Project	<b>IEEE 802.16 Broadband Wireless Access Working Group</b> < <a href="http://ieee802.org/16">http://ieee802.org/16</a> >	
Title	<b>Changes on Sleep Mode SDLs and MSCs</b>	
Date Submitted	<b>2004-01-15</b>	
Source(s)	Chulsik Yoon, Jaeheung Kim, Kunmin Yeo ETRI 161 Gajeong-Dong, Yuseong-Gu, Daejeon, Korea	Voice: +82-42-860-6826 Fax: +82-42-860-6732 mailto: <a href="mailto:csyoon@etri.re.kr">csyoon@etri.re.kr</a>
Re:	This is a response to a Call for Comments IEEE 802.16e-03/58 on IEEE 802.16e-03/07r5	
Abstract	This document contains suggestions to change the SDLs and MSCs reflecting working groups agreements on the Sleep Mode operation.	
Purpose	The document is submitted for review by 802.16e Working Group members.	
Notice	This document has been prepared to assist IEEE 802.16. It is offered as a basis for discussion and is not binding on the contributing individual(s) or organization(s). The material in this document is subject to change in form and content after further study. The contributor(s) reserve(s) the right to add, amend or withdraw material contained herein.

# Changes on Sleep Mode SDLs and MSCs

## 2. Proposed changes on Sleep Mode operation SDLs and MSCs in IEEE

Figure D.13 – Sleep Mode – MSS initiated awakening

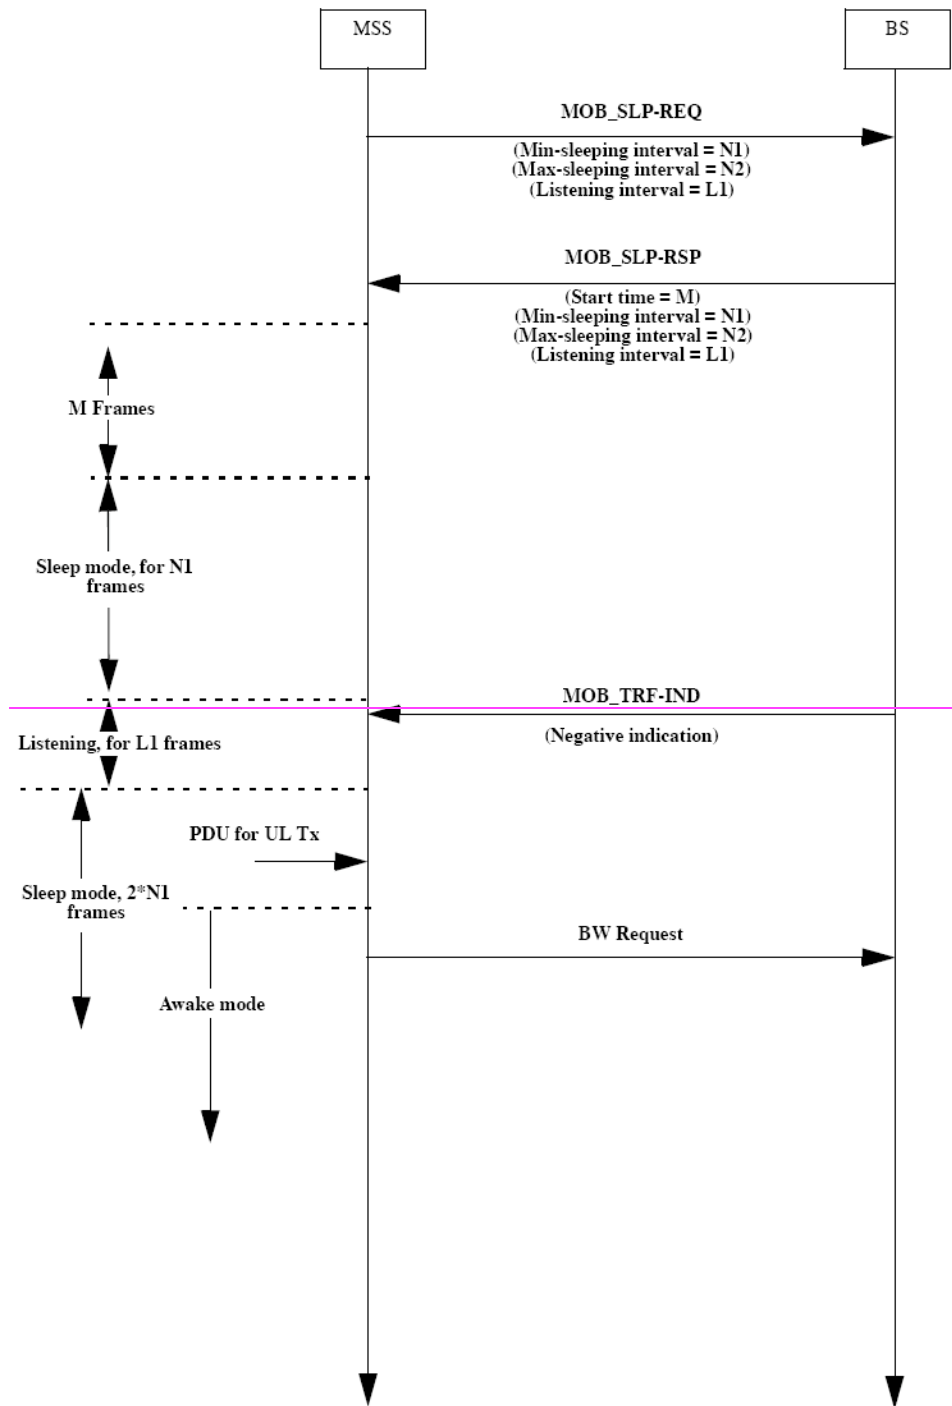
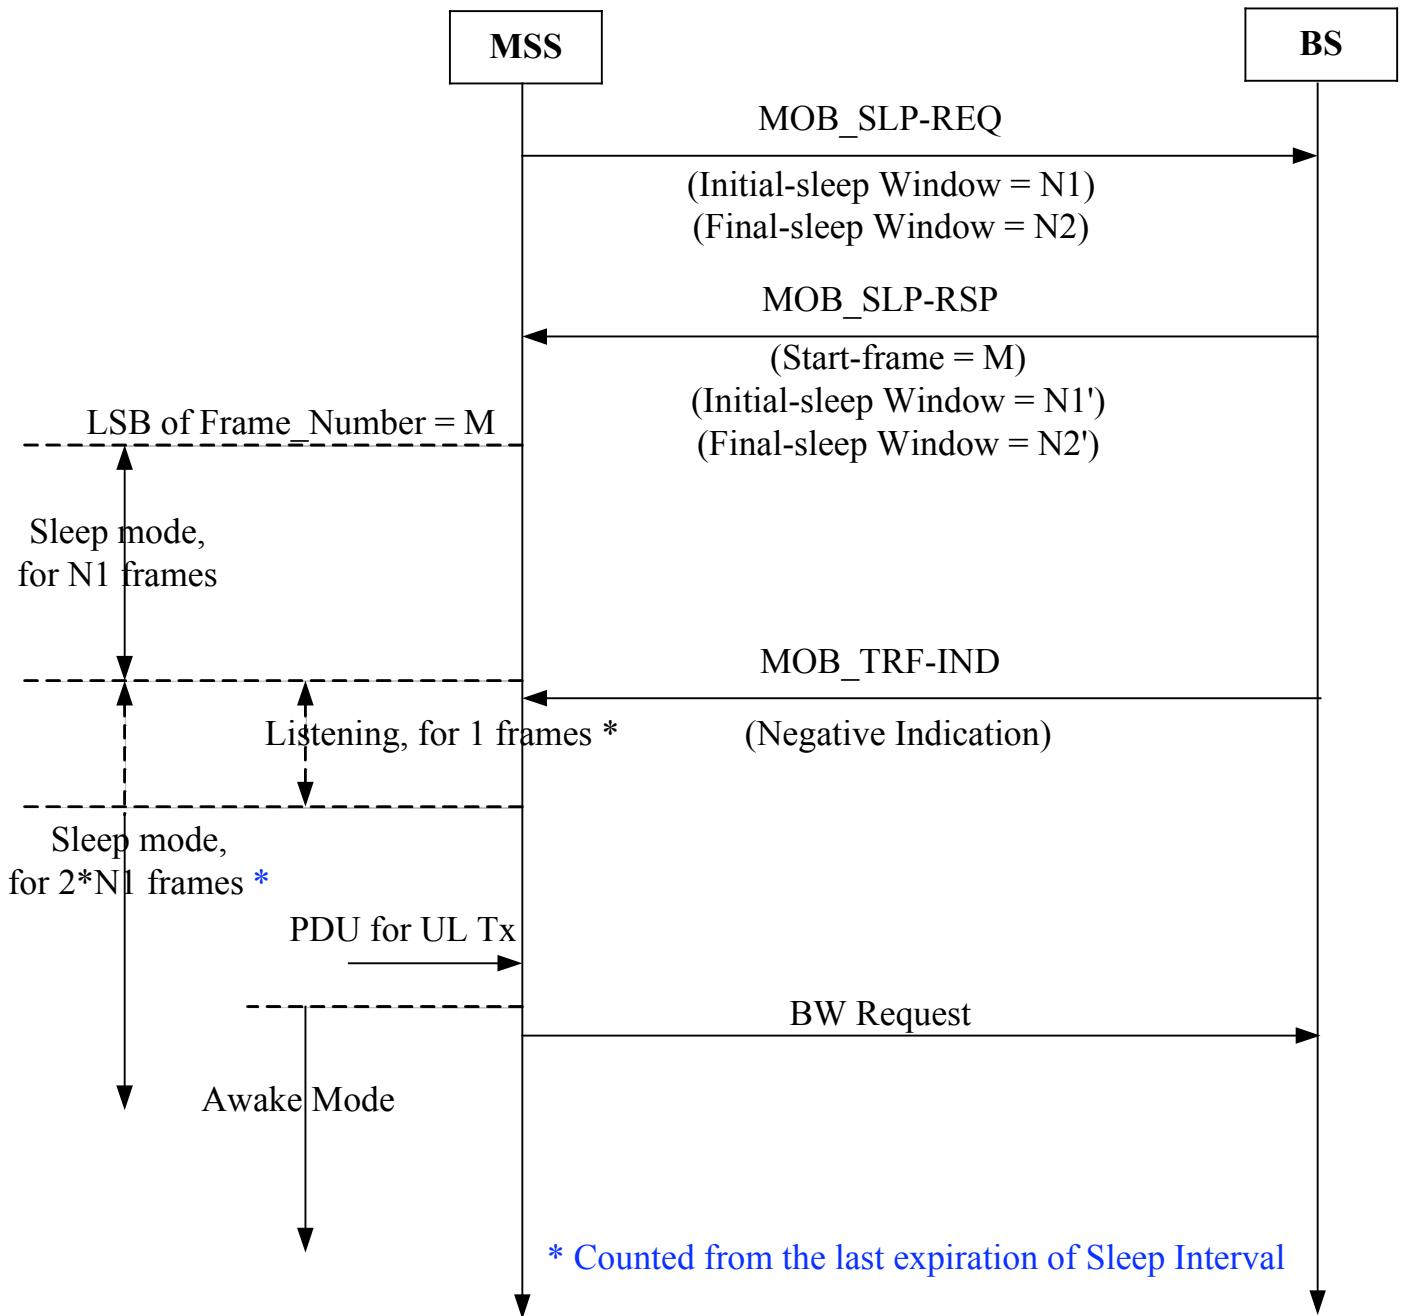
[Replace Annex D.2 Figure D.13 to the following:]  
 [From:]
